Amendment Determination Request for Montague Wind Power Facility – Phase 1

October 2018

CH2M HILL Engineers, Inc.
2020 SW 4th Avenue, Suite 300
Portland, OR 97201

Figure 1
Proposed Modifications to
Approved Site Boundary
Montague Wind Power Facility -
Amendment Determination Request

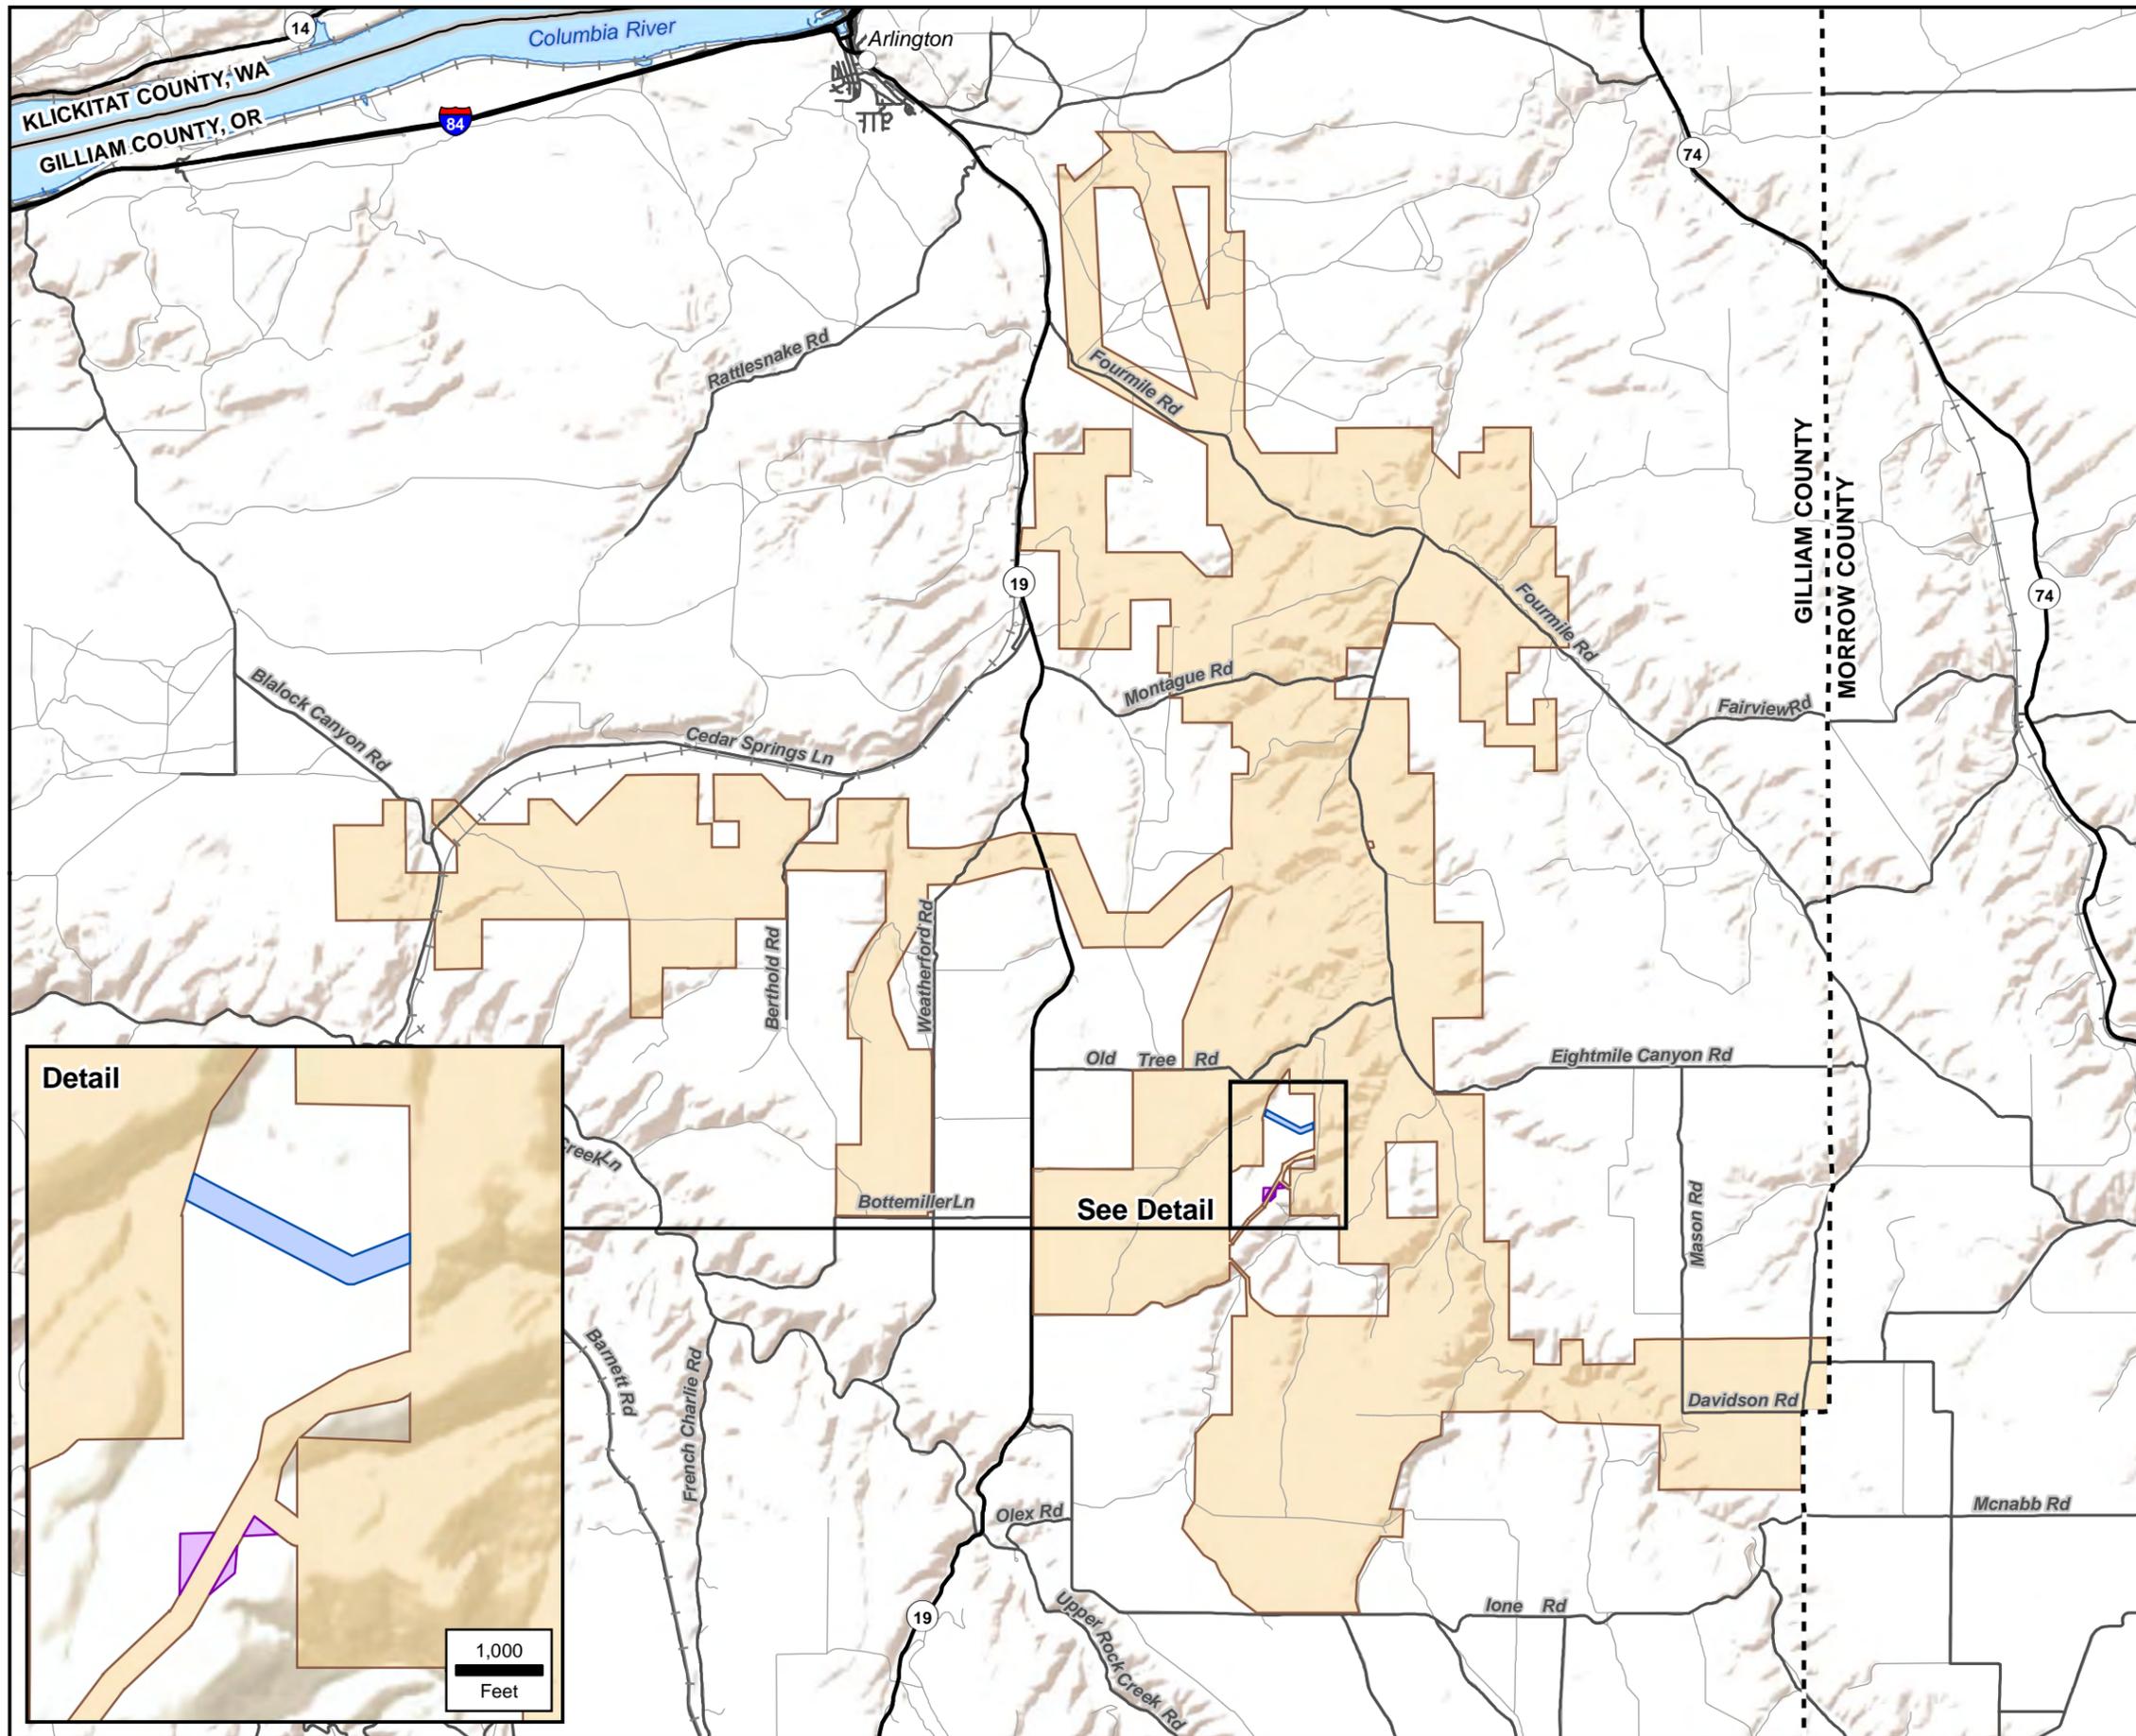
As shown in blue (“Collector Line Route”) on Figure 1, Montague will add approximately 20.6 acres to the approved site boundary for a collector line route between the H-string turbines and the collector substation. This area includes a 320-foot-wide corridor along a 2,830-foot-long underground collector route outside the site boundary. From turbine H6, Montague would install two circuits of buried collection lines across about 700 linear feet of the Crum Ranch property and then about 3,000 linear feet across Weedman Ranch property before transiting to an overhead line on Athern Ranch property for 2,080 feet to the collector substation (see Figure 2). Installation of buried collector outside the approved site boundary would occur in the same manner as previously approved in the Final Order⁶, and have similar or less impacts to a comparable route within the approved site boundary (Table 2).

As shown in purple (“Access Road Modifications”) on Figure 1, Montague seeks to add approximately 5.2 acres to the approved site boundary and micro-siting corridor to modify the access road segment from the G turbine string to the H turbine string across the Weedman Ranch property. This access road corridor was previously added to the site boundary as part of Change Request 3⁷. Now Montague is considering three different alignments for the access road to turbines H8 and H9 (see Attachment 2). These options are intended to address the landowner’s request related to the direction of plowing, but are slightly outside of the corridor previously defined in Change Request 3. The length of the access road to the H turbine string would generally be the same with each of the alignment options (within 500 ft).

Civil Plan H6-H9

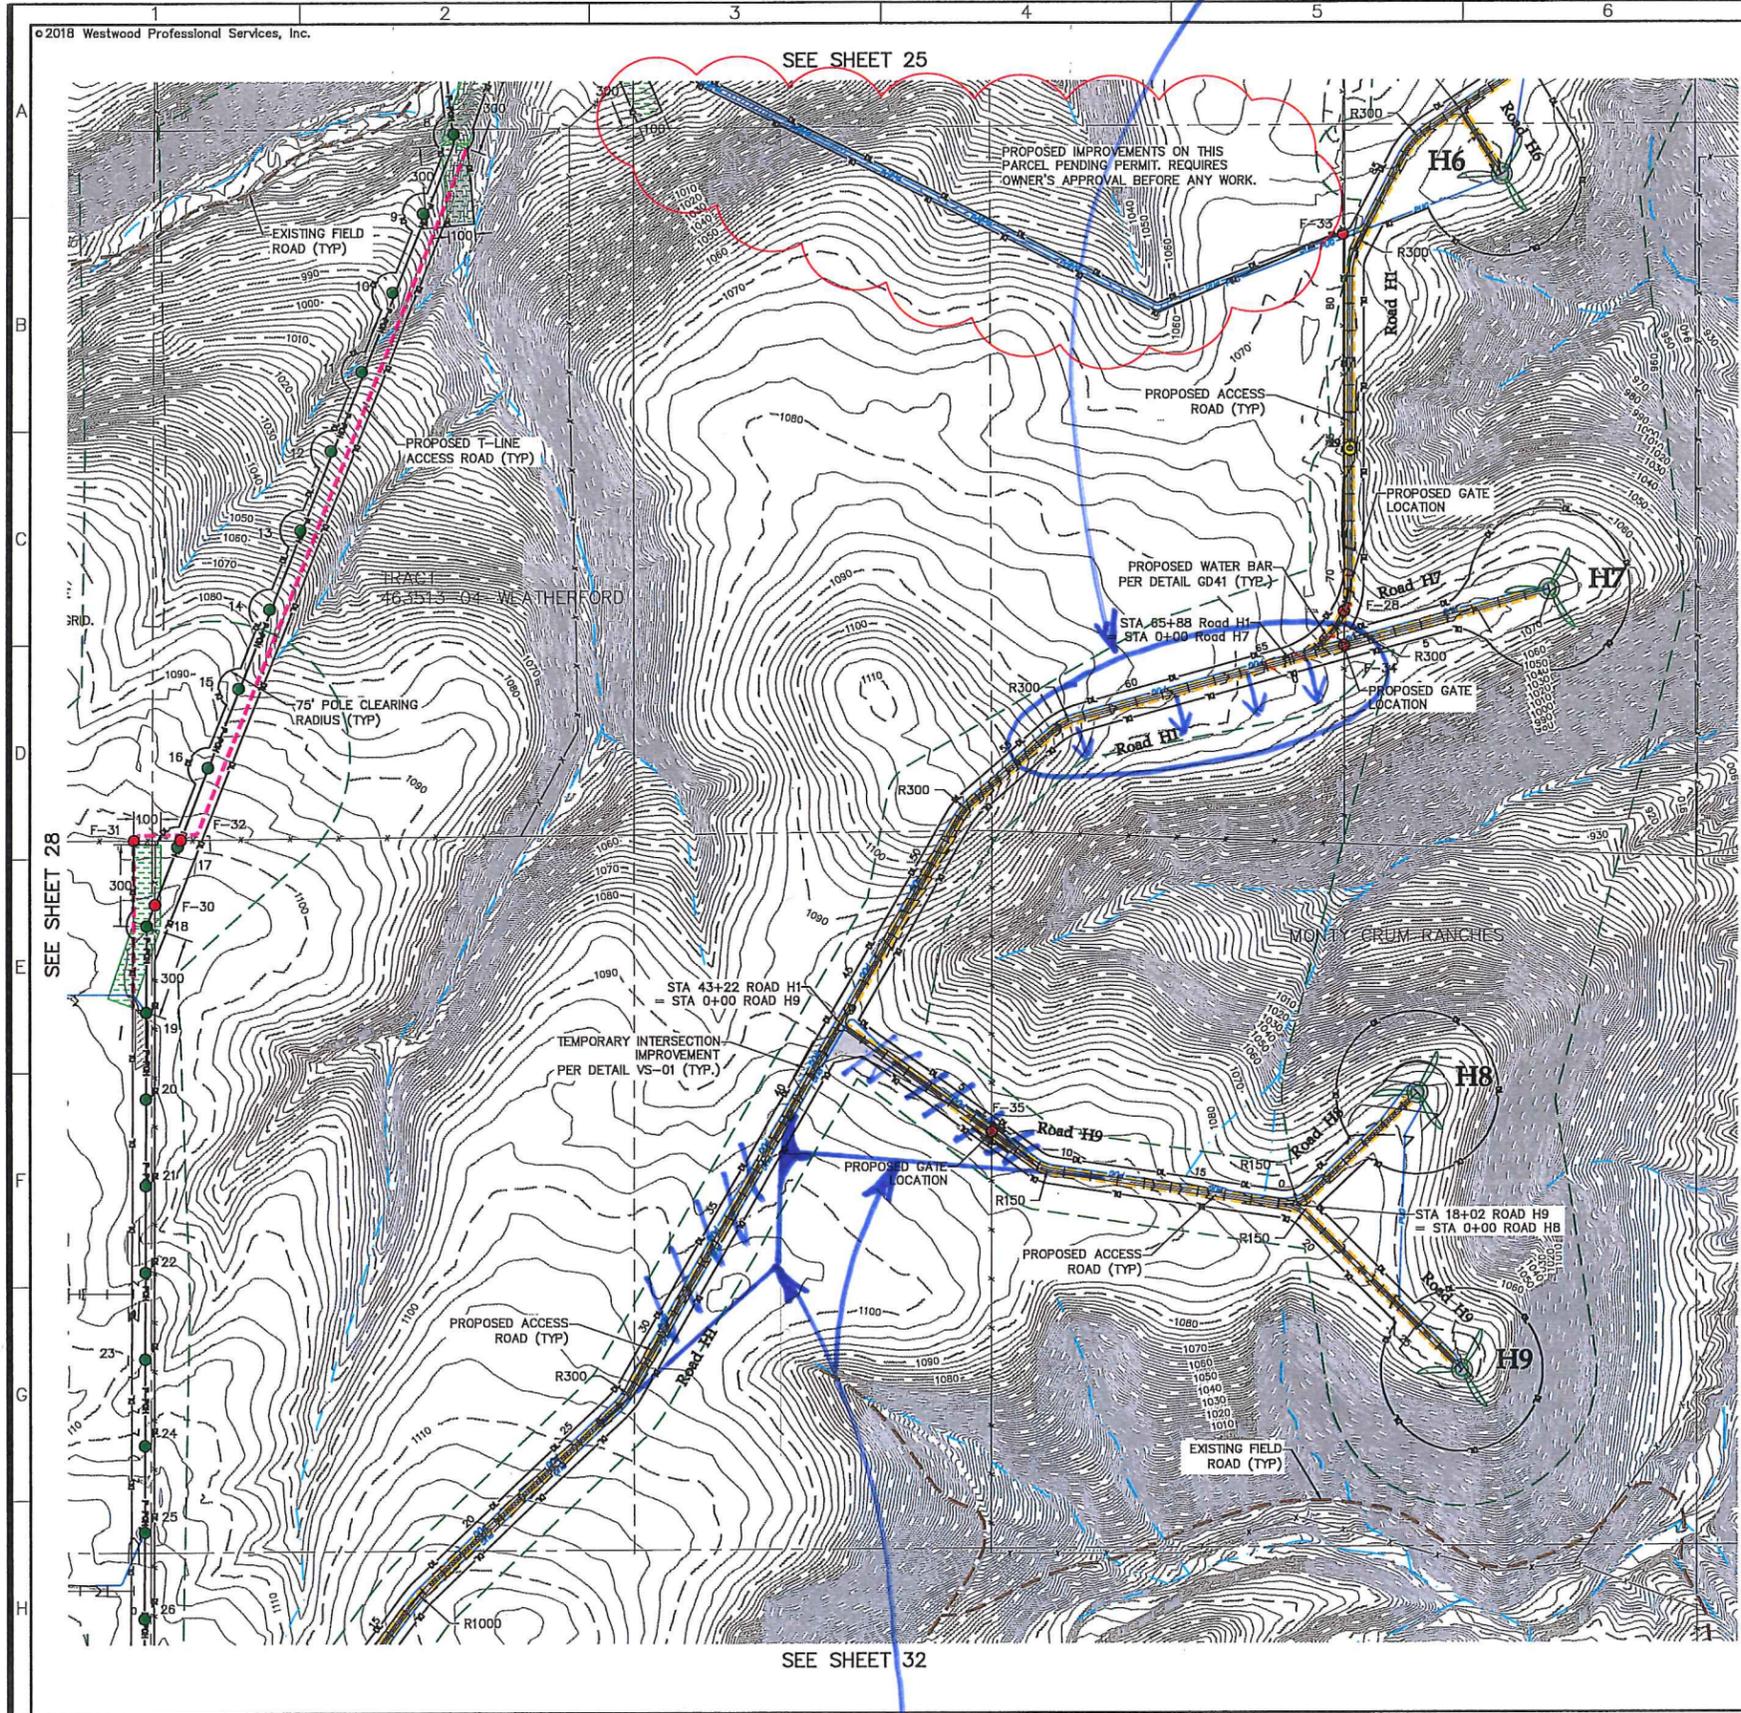
POSSIBLE TO MOVE ROAD CLOSER TO FIELD EDGE?

POSSIBLE REALIGNMENT OPTION ①
